Intex Link Garments (BD) Limited

Observations

**Extension to Lift Machine Room roof slab
not shown on drawings and supported by
unrestrained brickwork**

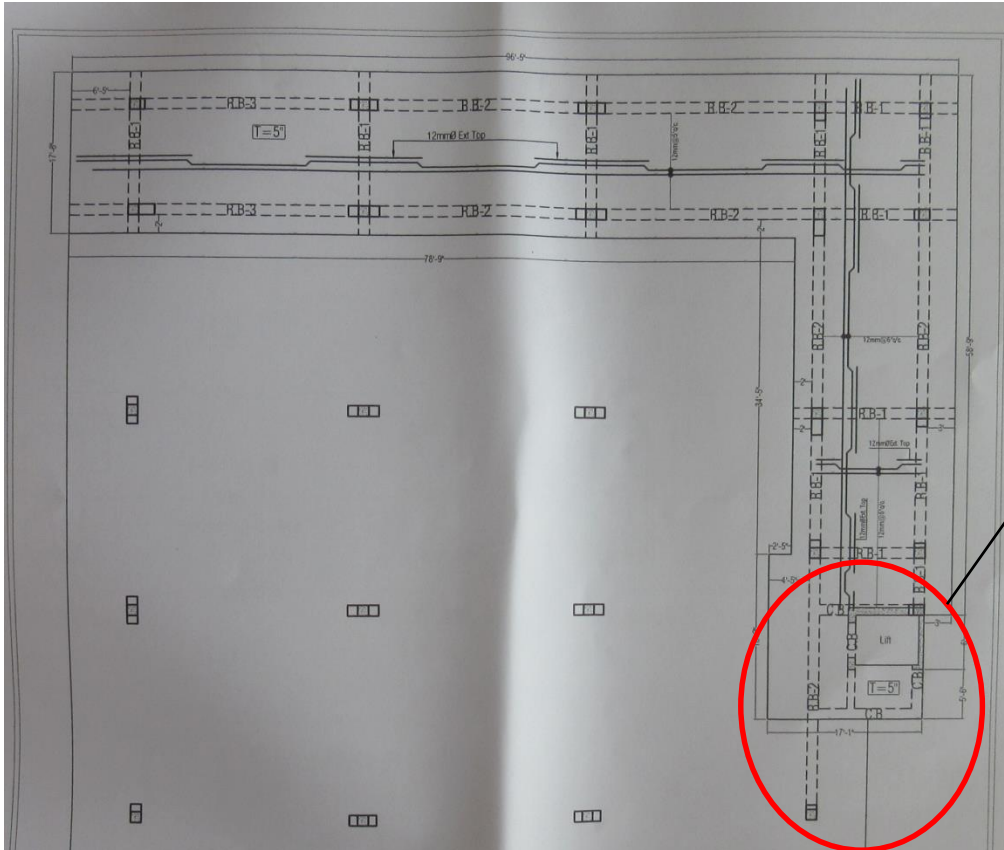
4.28m high brick piers

2.4m high brick wall

An extension to the Lift Machine Room slab supported on one side by two 4.28m high brick piers, partially restrained by a 2.4m high brick wall. No obvious lateral restraint to brick panel on NE edge of main roof slab

Item No.	Observation	Recommended Action Plan	Recommended Timeline
1	Extension to Lift Machine Room roof slab not shown on drawings and supported by unrestrained brickwork	Building Engineer to assess whether lateral restraint has been provided to the brick panel in the NE corner of the roof slab	6-weeks
2	Extension to Lift Machine Room roof slab not shown on drawings and supported by unrestrained brickwork	Provide lateral restraint to brick panel if necessary	6-months
3	Extension to Lift Machine Room roof slab not shown on drawings and supported by unrestrained brickwork	Revise drawings to show extension of LMR roof slab and supporting structure	6-months
4	Brick stub columns under the water reservoir bearing on main slab	Building Engineer to assess loading on the roof slab from brick stub columns under the water reservoir, and the capacity of the beams and slabs to resist that loading	6-weeks
5	Brick stub columns under the water reservoir bearing on main slab	Adjust loading by removing stub columns or strengthen the beam and slab structure if necessary to accommodate anticipated loading	6-months

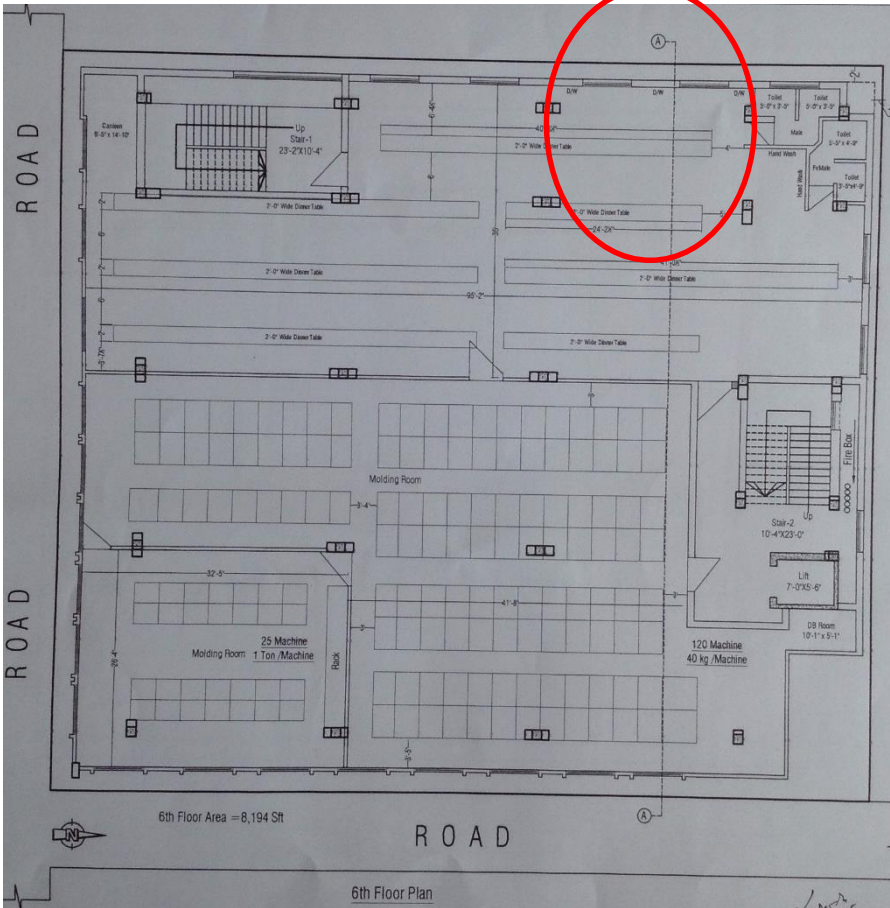
The extended portion of lift machine room top slab is not shown on drawings
